**BEFORE THE PUBLIC UTILITY COMMISSION
OF OREGON**

LC 77

2021 Integrated Resource Plan.

Initial Comments of
Renewable Northwest

Figure 1. Summer and winter 1-hour peak surplus or deficit from the 2016 to 2021 Northwest Regional Forecasts.¹⁰ The bold lines are 2021 projections.

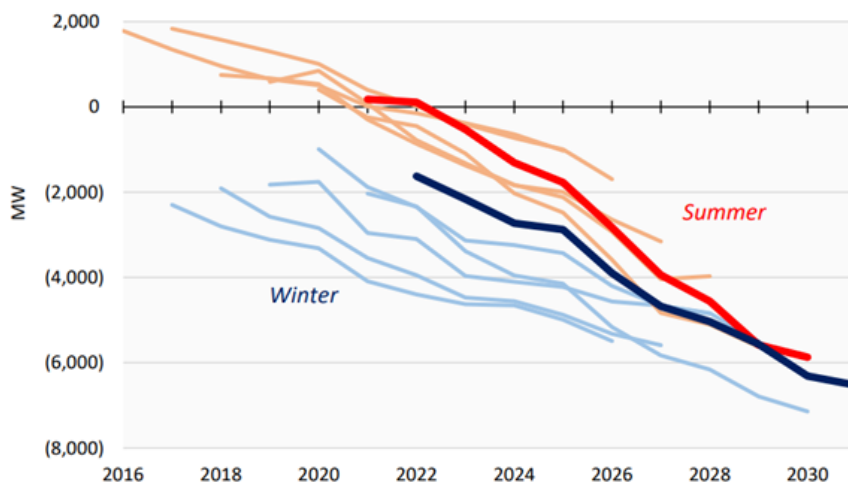
The 2021 IRP mentions that “recent weather-based reliability events throughout the United States have underscored the need for utilities to consider the potential for increasingly extreme weather and the underlying reliability challenges that may be caused as part of its planning process.” The Pacific Northwest has been a winter-peaking region historically but that is now changing with the weather-related impacts of climate change. Warmer weather events across the year are shifting the high loss-of-load-probability hours from the winter to the summer.⁹ A

similar effect can be observed in PacifiCorp’s territory. Changes in weather necessitate procurement of resources that can operate efficiently during these weather conditions.

With expected reductions in hydro generation¹¹ during the summer and increasing thermal forced outages, PacifiCorp would require large swathes of hybrid resources i.e. renewables paired with energy storage as well as standalone energy storage resources to provide clean and firm capacity across the year especially during the summer evenings. Weather-related thermal outages could be considered in future IRPs by developing a modeling framework which changes the output of thermal resources based on weather conditions. On the other hand, hybrid resources, specifically, solar plus storage or wind plus storage, can be implemented in various configurations based on the company’s needs and are typically more reliable during summer peaking conditions. Broadly, they are categorized into AC-coupled and DC-coupled systems, with each having its own benefits. Recently, PacifiCorp’s 2022AS RFP Team noted that they *would not* consider DC-coupled solar plus storage bids in this RFP because of difficulty in synergizing with California ISO and lack of sufficient metering infrastructure. This restriction, if not urgently addressed through engagement with CAISO and project developers, would create risks for PacifiCorp and its customers in its ability to procure the most cost-effective and clean capacity resources.
